## **Public Hearing on NPDES Permit NC0004774 Duke Energy Carolinas, LLC Buck Combined Cycle Station**

**June 13, 2018  
Rowan County Cooperative Extension  
Salisbury, North Carolina**

**SUBJECT:** Hearing Officer's Report and Recommendations  
Duke Energy Carolinas, Draft NPDES Wastewater Permit No. NC0004774  
Buck Combined Cycle Station, Rowan County

**FIGURE 1**  
**WASTE AND COMPLIANCE BOUNDARIES**  
**BUCK STEAM STATION**  
**DUKE ENERGY CAROLINAS, LLC**  
**SALISBURY, NORTH CAROLINA**

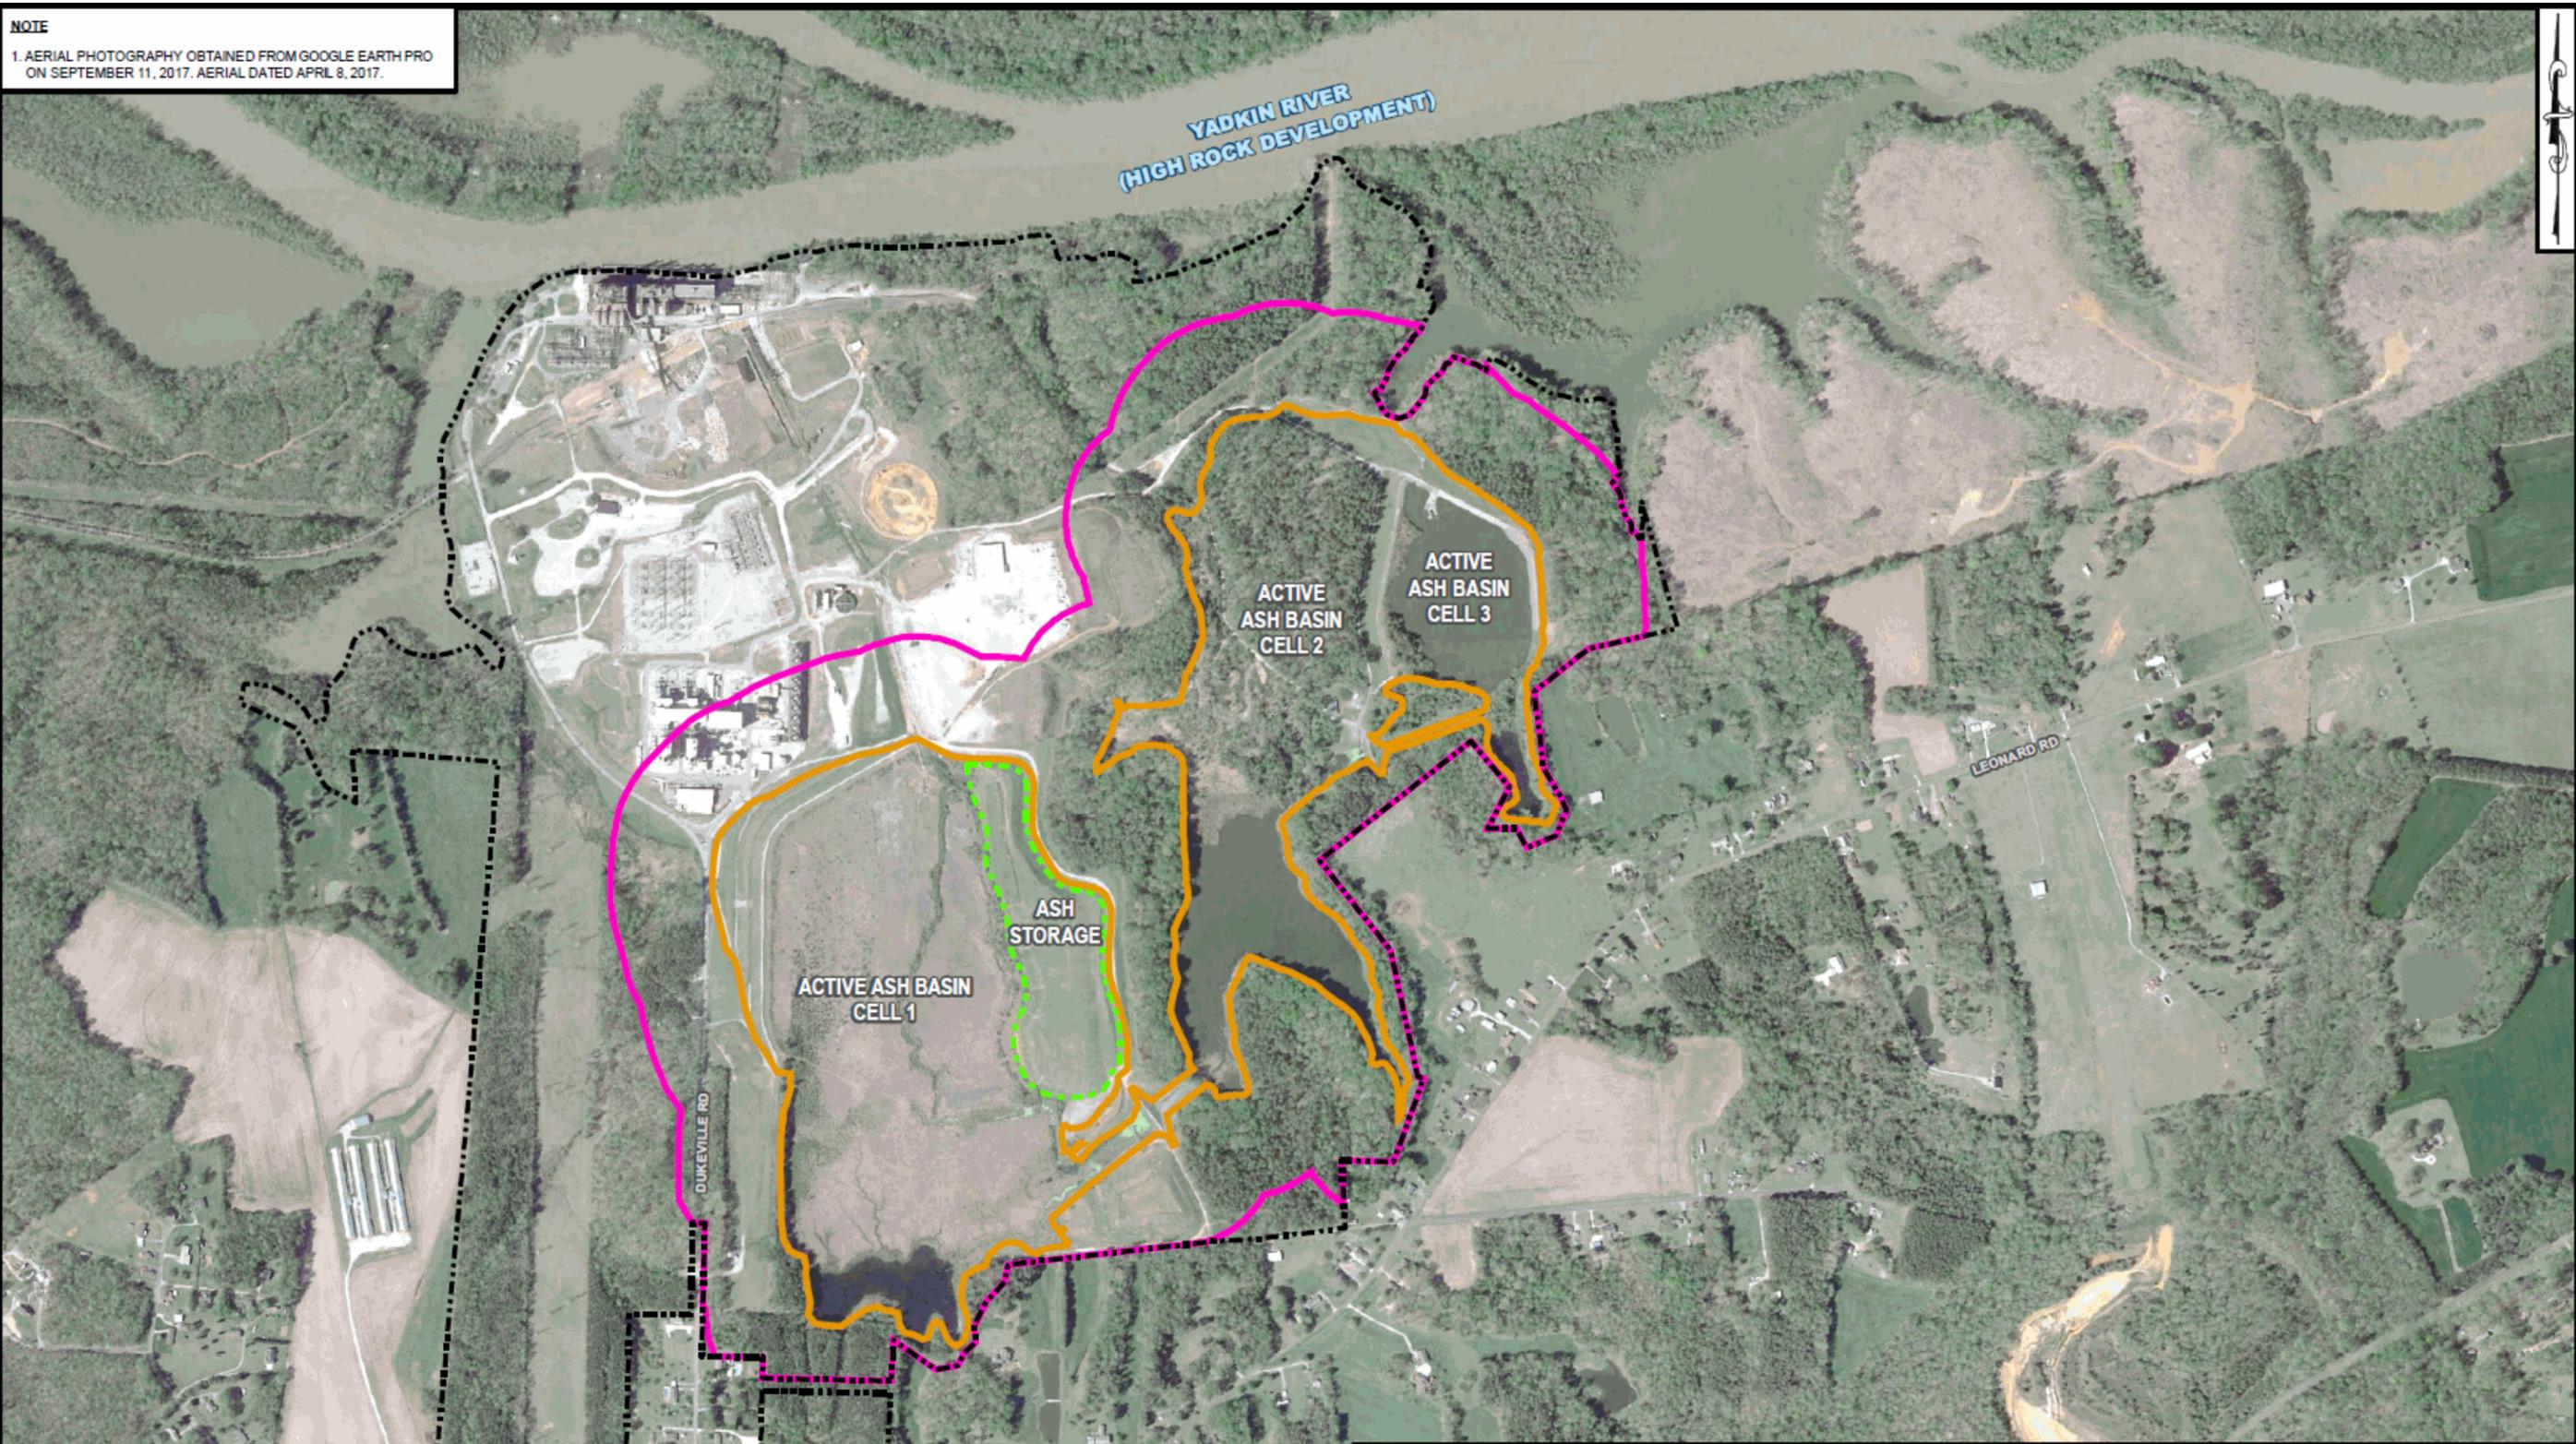
- **Comment:** Addition of compliance boundary map and condition: "We support the additions of a compliance boundary map and related condition C.(17.) as important steps toward enforcing the 2L Rule at Buck Steam Station."

**Response:** Comment noted.
